# UNITED STATES PATENT AND TRADEMARK OFFICE

APPLICATION NO.	FILING DATE	FIRST NAMED INVENTOR	ATTORNEY DOCKET NO.	CONFIRMATION NO.
10/564,582	01/12/2006	Celine Juliette Detecheverry	NL03 0878 US1	3317

<b>Office Action Summary</b>	<b>Application No.</b> 10/564,582	<b>Applicant(s)</b> DETECHEVERRY ET AL.	
	<b>Examiner</b> JOSELITO BAISA	<b>Art Unit</b> 2832

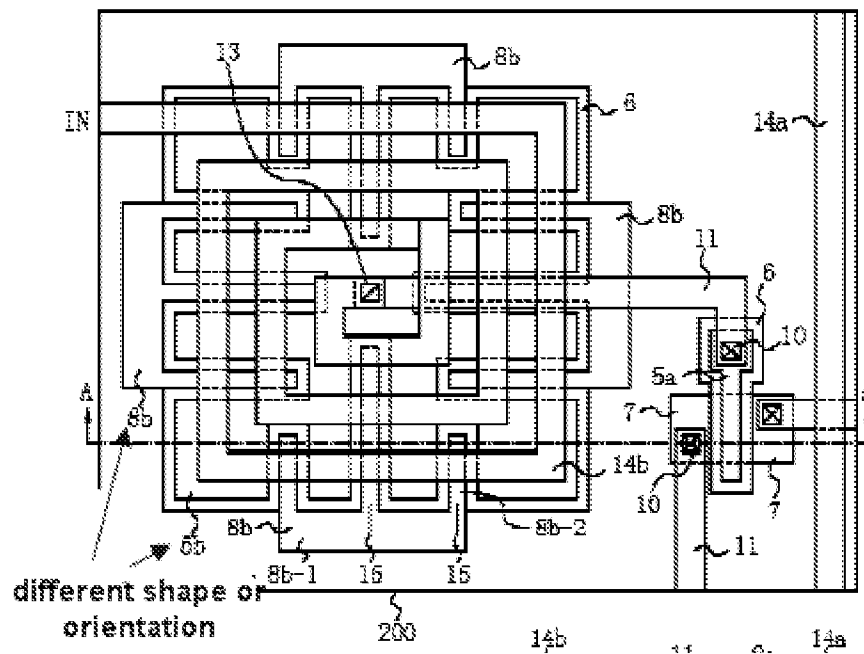
Applicant argues that the cited portion of Hiromoto appears to be a ground shield instead of a tilling structure. That is not correct.

Hiromoto discloses a layer of polysilicon pattern 5b in between the inductive element 14b and the substrate 1. Metal silicide 8b disposed on polysilicon 5b for the purpose of eliminating the noise generated by coupling of inductive element and the substrate 1. But since eddy current occurs in metal silicide layer lowers down the quality factor Q, Hiromoto introduces slits 15 to eliminate this problem. The slits created a finge- like structure electrically connected to a central strip. Similar to the specified structure of the applicant on Page 8, Lines 10-13. This structure pattern (8b, 5b), tilling structure, has a shape that substantially inhibits an inducement of an image current in the structure due to the current flowing through the conductor of the inductive element 14.

Hiromoto has the desired pattern density in its tilling structure, as shown in Figure 1.

With regards to claim 4, Applicant argues that the cited portions 5b and 8b of Hiromoto are have the same shape and orientation. The Examiner disagrees.

Shown in this annotated Figure of Hiromoto (Figure 1) that 5b and 8b are of different shape and orientation.
